CITY OF ALBUQUERQUE

Re: Pond Gardens
1800 Candelaria rd
Traffic Circulation Layout
Architect's Stamp **08-20-18** (G13-D036)

TRAFFIC CIRCULATION LAYOUT

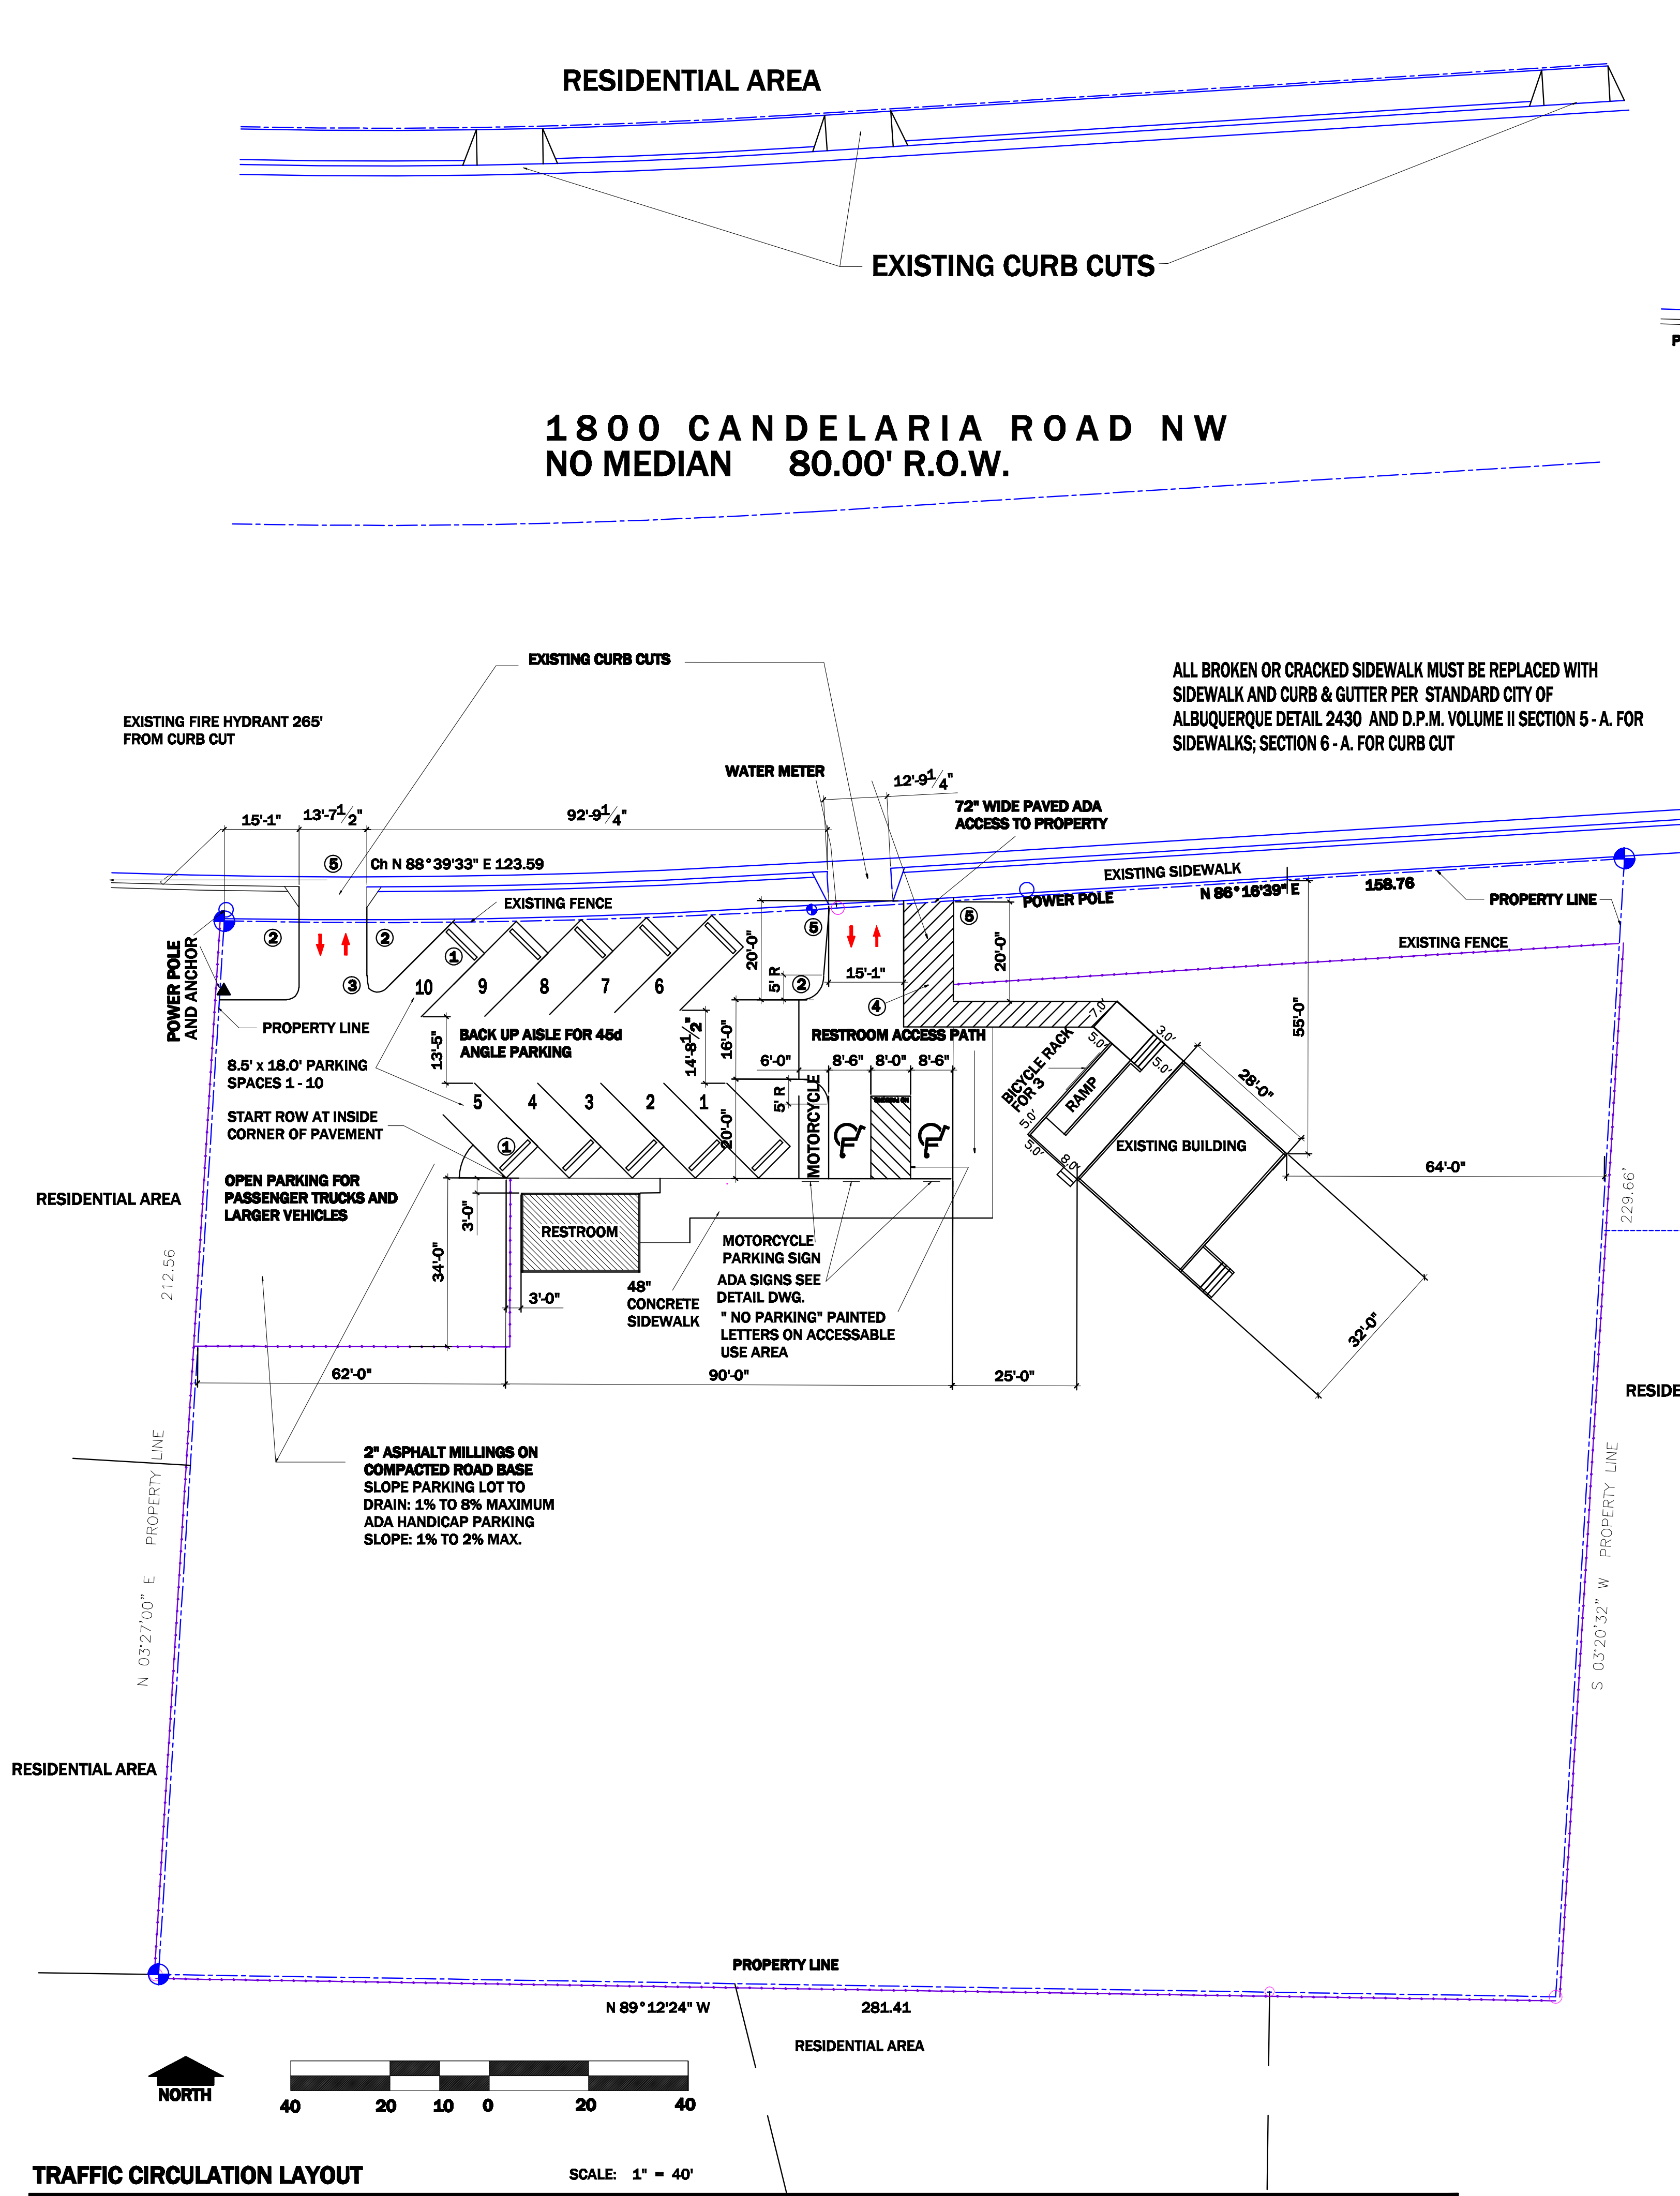
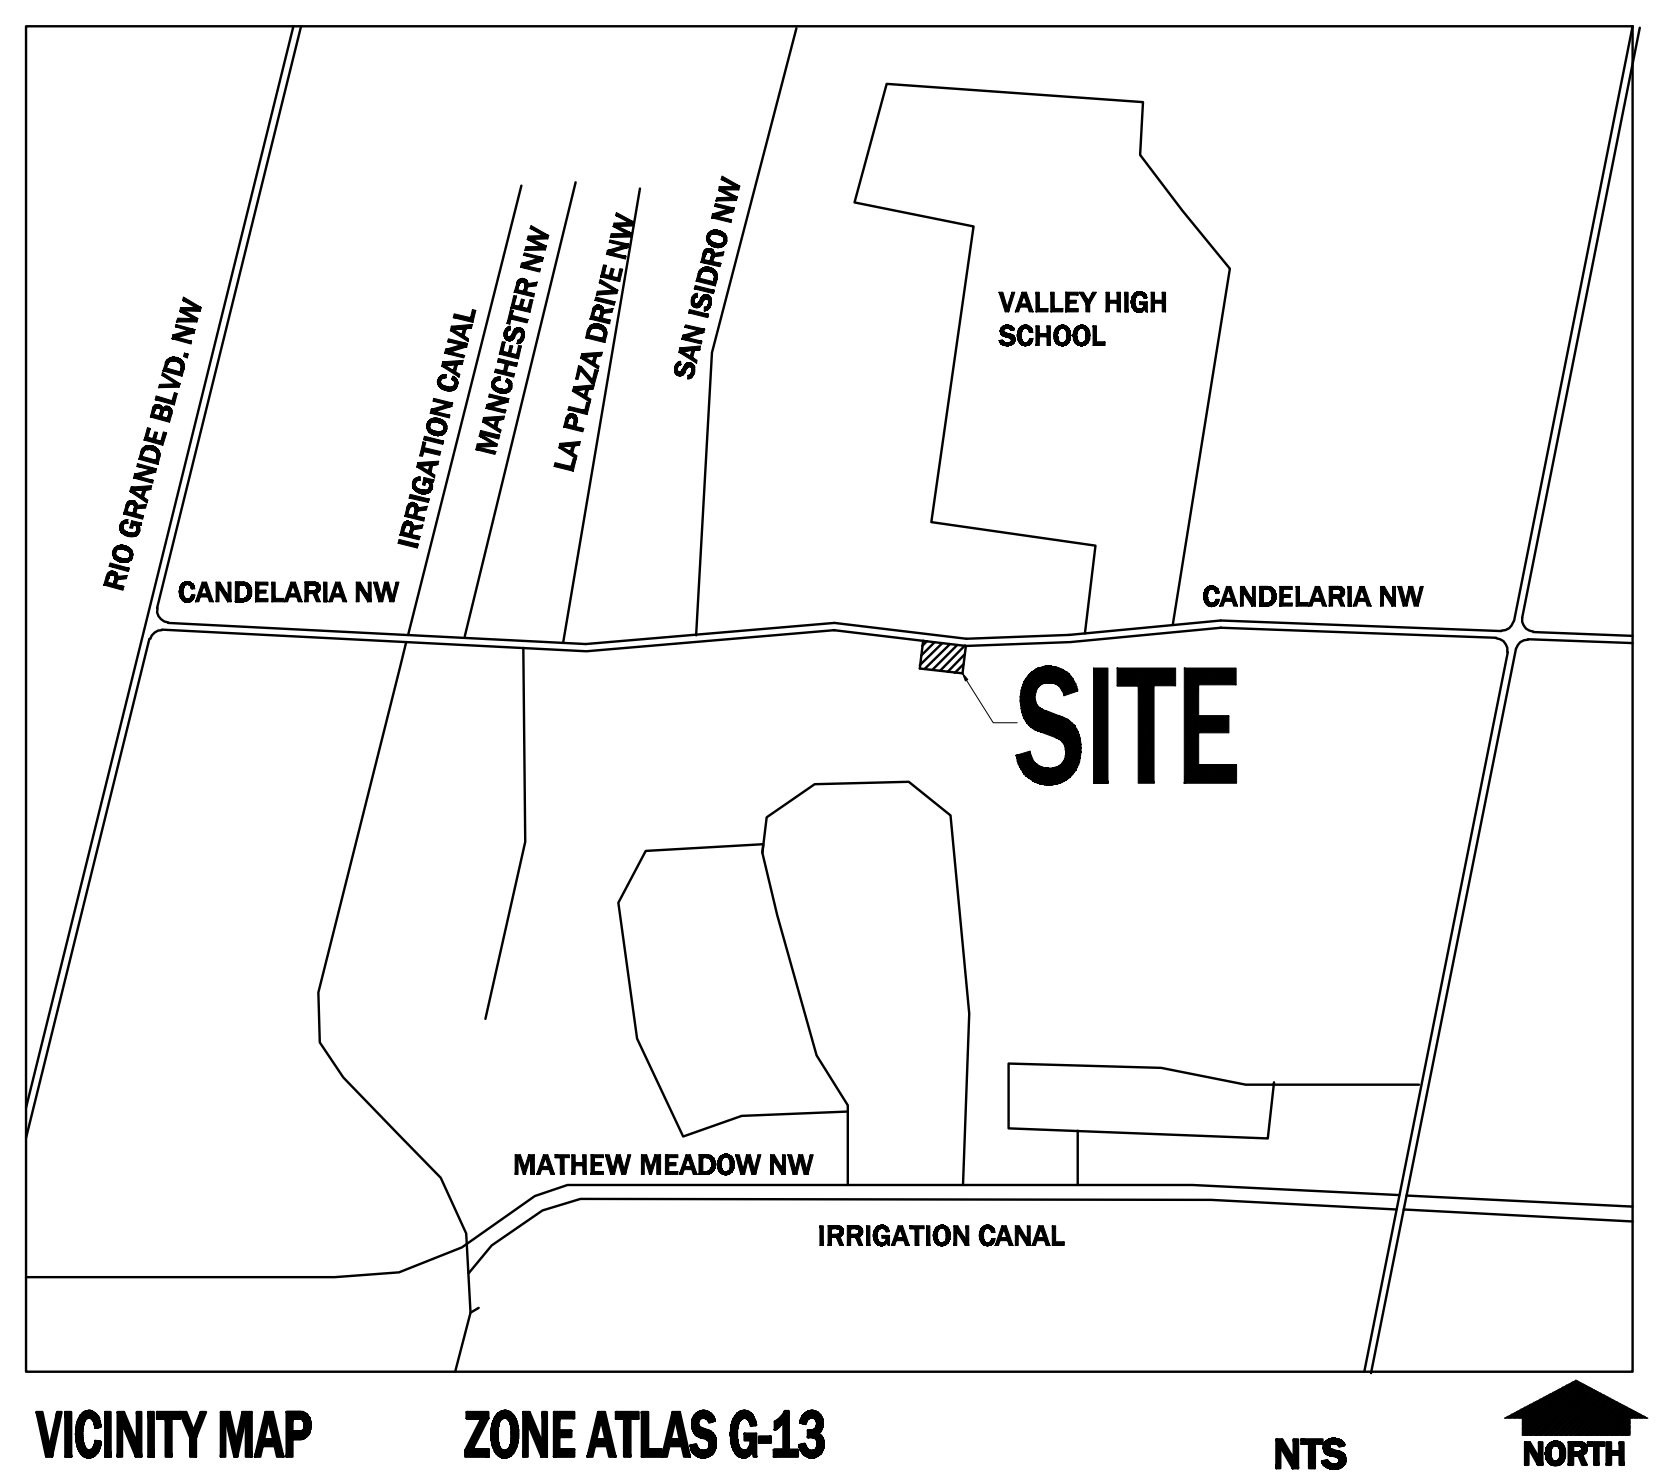
1. One-way vehicular paths require pavement directional signage and a posted **"Do Not Enter"** sign at the point of egress. Please show detail and location of posted signs.
2. The Driveway widths are not wide enough for two way travel and the site is setup for one-way traffic. One way drives on roadways classified as arterial should be 20 feet wide per Ch 23 section 6 of the DPM.

Resubmit a revised plan along with fully completed Drainage Transportation Information Sheet to front counter personnel for log in and evaluation by Transportation. PDF copies of the plans and submittal package must be emailed to PLNDRS@cabq.gov at time of resubmittal. If you have any questions, please contact me at 924-3630.
